HARBOR ISLE 3RD ADDITION

TO WICHITA - SEDGWICK COUNTY, KANSAS

RE: S/D 99-40 -- One-Step Final Plat of HARBOR ISLE THIRD ADDITION

CASE NUMBER: S/D 99-40 -- HARBOR ISLE 3RD ADDITION

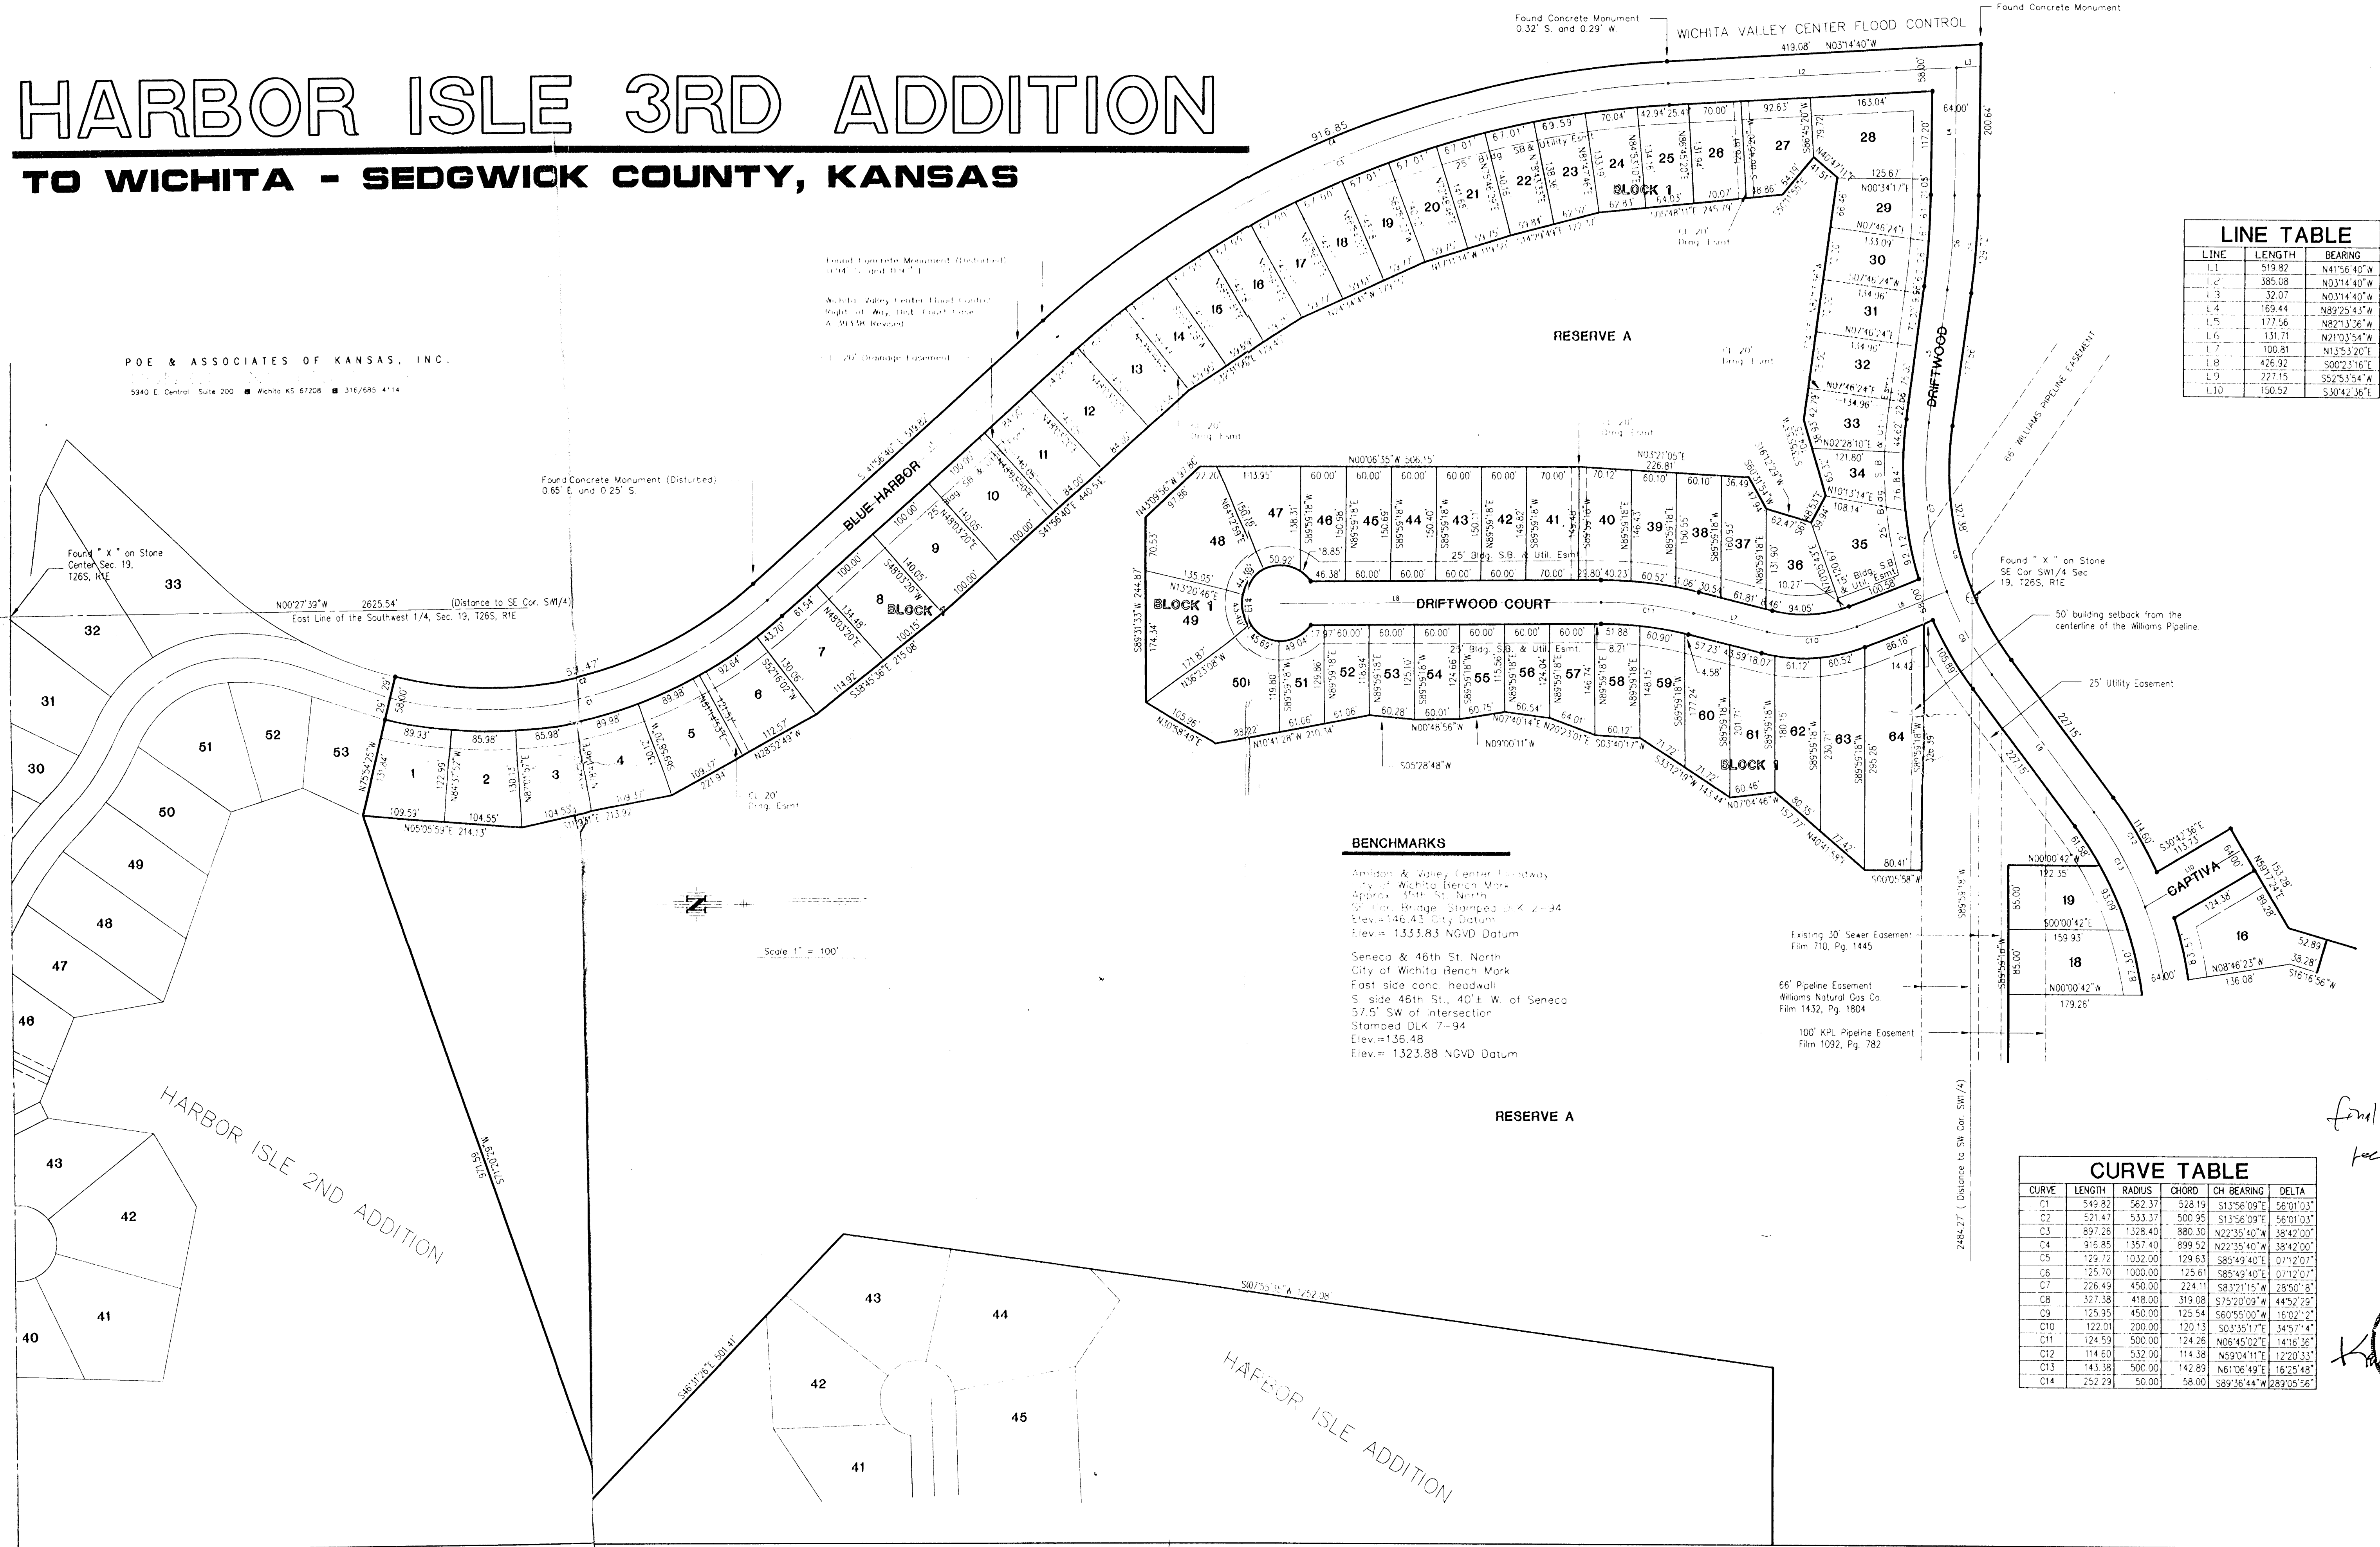
- N. City Fire shall comment on the names of the interior streets. On Sheet 2, Driftwood Circle shall be renamed Driftwood Court. Sannibel will be renamed Blue Harbor.
